SUBJECT: JAMES A FITZPATRICK NUCLEAR POWER PLANT- STAFF ASSESSMENT OF INFORMATION PROVIDED PURSUANT TO TITLE 10 OF THE *CODE OF FEDERAL REGULATIONS* PART 50, SECTION 50.54(f), SEISMIC HAZARD REEVALUATIONS FOR RECOMMENDATION 2.1 OF THE NEAR-TERM TASK FORCE REVIEW OF INSIGHTS FROM THE FUKUSHIMA DAI-ICHI ACCIDENT (CAC NO. MF3725)

STAFF ASSESSMENT BY THE OFFICE OF NUCLEAR REACTOR REGULATION

RELATED TO SEISMIC HAZARD AND SCREENING REPORT

JAMES A. FITZPATRICK NUCLEAR POWER PLANT

Figure 3.3-1 Plot of Staff's and Licensee's Base Case Shear-Wave Velocity Profiles for the JAF site

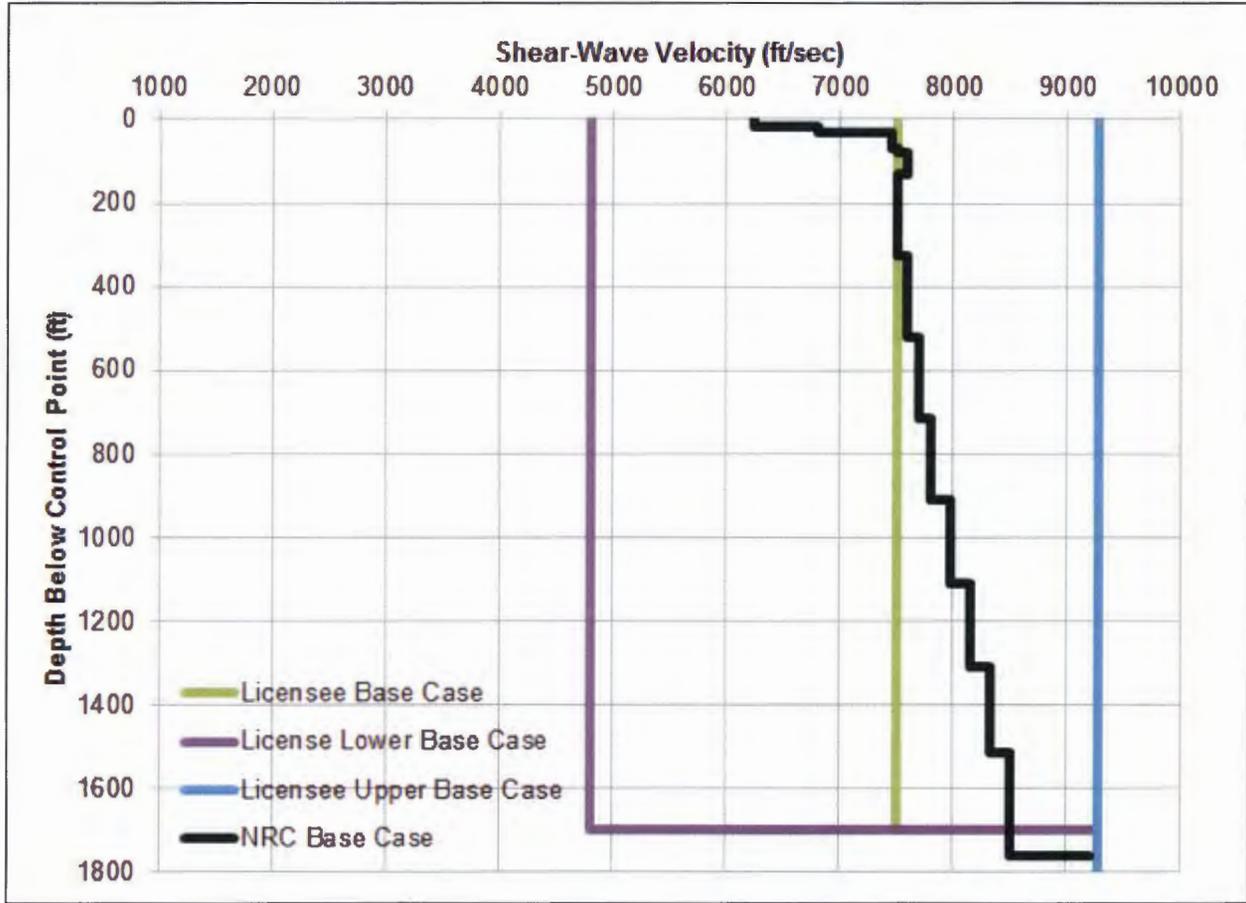
To characterize subsurface geology, the licensee developed three site base case profiles at the JAF site. The middle, or best estimate, profile was developed by taking the mean of the shear-wave velocity measurements for the Oswego Sandstone ($V_s = 7,500$ ft/sec or 2,286 m/sec) to a depth of 1,700 ft (518 m) from the control point to hard reference rock. The licensee developed the upper and lower base case profiles using a natural log standard deviation of 0.35. Table 2.3.2-1 and Figure 2.3.2-1 of the SHSR provide the licensee's shear-wave velocity profile for each of the three base cases. Figure 3.3-1 of this assessment shows the licensee's three shear-wave velocity base case profiles.

Because abundant geophysical measurements were made at the proposed NMP3 site, which is located less than one mile (1.6 km) from the JAF site, and the sub-surface stratigraphy between the two sites appears to be relatively uniform, the NRC staff used the shear wave velocities measured beneath NMP3 for its site response confirmatory analysis. In addition, because these shear wave velocities for the proposed NMP3 site were measured using modern methods and analyses, the NRC staff used only a single shear wave velocity profile rather than the three profiles developed by the licensee for its site response analysis. To capture the uncertainty in the depth to reference or base rock, the NRC staff randomized the total profile thickness of 1,700 ft (518 m) value by ± 150 ft [± 46 m]. Figure 3.3.-1 of this assessment shows the NRC staff velocity profile compared to the base case profiles developed by the licensee. As shown in Figure 3.3-1, the licensee's three base case profiles encompass a much larger range of shear

wave velocities than the range of velocities reported in the proposed NMP3 SAR (UniStar, 2009).

Figure 3.3-3 Plot Comparing the Staff's and the Licensee's Mean Control Point Hazard Curves at a Variety of Frequencies for the JAF site

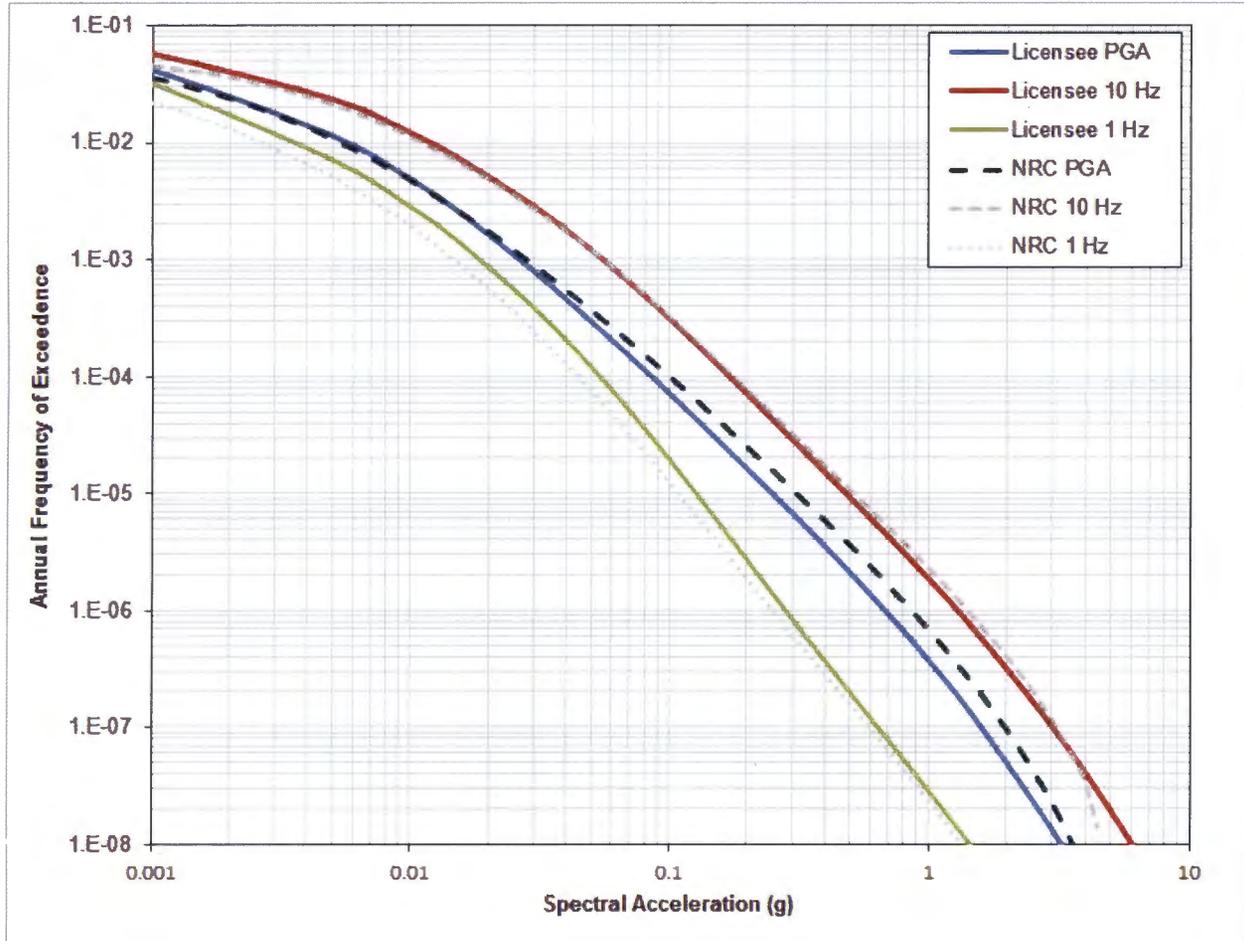
Overall the licensee's approach to modeling the subsurface rock properties and their uncertainty results in lower site amplification factors relative to the staff's results, particularly at high frequencies. As shown in Figure 3.3-3 of this assessment, these differences in the site response analysis have a minor impact on the 1 and 10 Hz control point seismic hazard curves; however, the NRC staff's confirmatory PGA or 100 Hz hazard curve is somewhat higher than the licensee's PGA hazard curve. Appendix B of the SPID provides guidance for performing site response analyses, including capturing the uncertainty for sites with less subsurface data; however, the guidance is neither entirely prescriptive nor comprehensive. As such, various approaches in performing site response analyses, including the modeling of uncertainty, are acceptable for this application.

In summary, the NRC staff concludes that the licensee's site response was conducted using present-day guidance and methodology, including the NRC-endorsed SPID. The NRC staff performed independent calculations which confirmed that the licensee's amplification factors and control point hazard curves adequately characterize the site response, including the uncertainty associated with the subsurface material properties, for the JAF site.

Figure 3.4-1 Comparison of the Staff's GMRS with Licensee's GMRS and the SSE for the JAF site

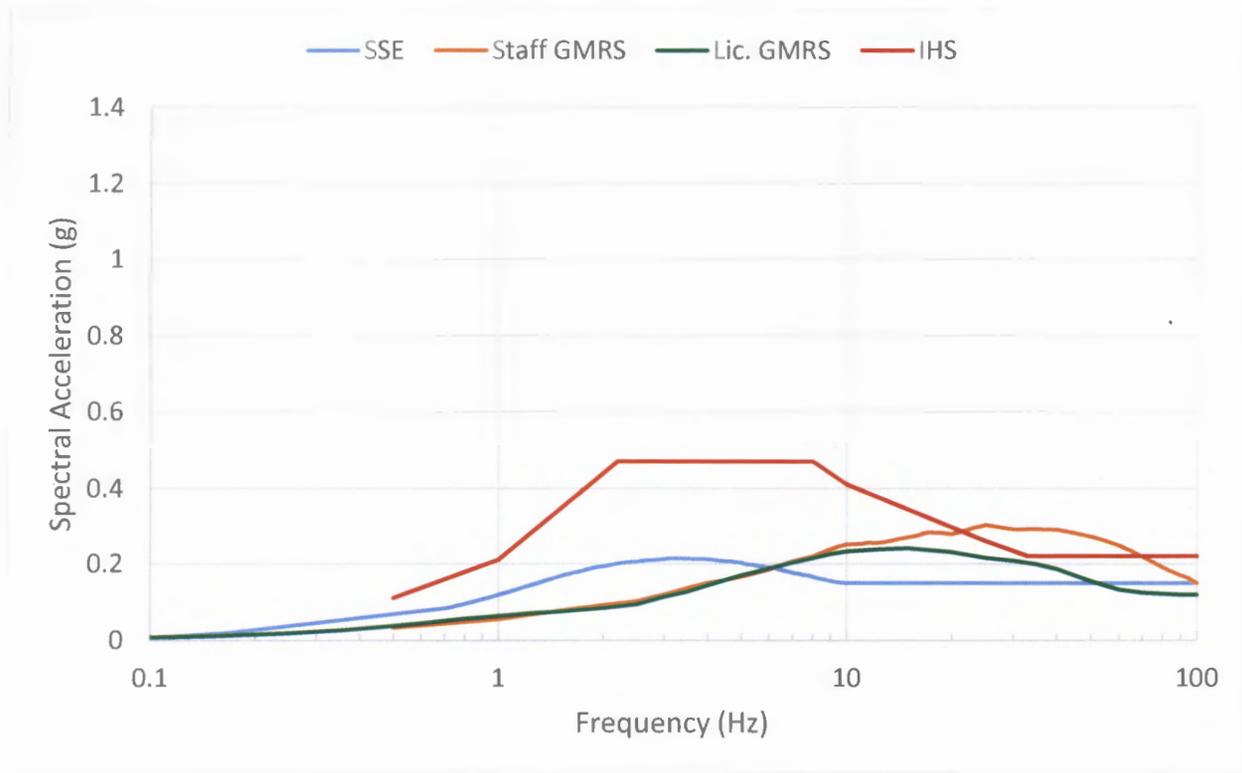
The NRC staff independently calculated the 10^{-4} and 10^{-5} UHRS using the results of its confirmatory PSHA and site response analyses, as described in Sections 3.2 and 3.3 of this staff assessment, respectively. Figure 3.4-1 of this assessment shows a comparison of the GMRS determined by the licensee to that determined by the NRC staff.

As shown in Figure 3.4-1, the licensee's GMRS shape is very similar to that calculated by the NRC staff at frequencies less than 10 Hz. However, the NRC staff's confirmatory GMRS is somewhat higher than the licensee's at frequencies above 10 Hz. As described above in Section 3.3, the NRC staff concludes that these minor differences over the higher frequency range are primarily due to the differences in the site response analyses performed by the licensee and the NRC staff.

The NRC staff confirms that the licensee used the present-day guidance and methodology outlined in RG 1.208 and the SPID to calculate the horizontal GMRS, as requested in the 50.54(f) letter. The NRC staff performed both a PSHA and site response confirmatory analysis and achieved results consistent with the licensee's horizontal GMRS. As such, the NRC staff concludes that the GMRS determined by the licensee adequately characterizes the reevaluated hazard for the JAF site. Therefore, this GMRS is suitable for use in subsequent evaluations and confirmations, as needed, for the response to the 50.54(f) letter.
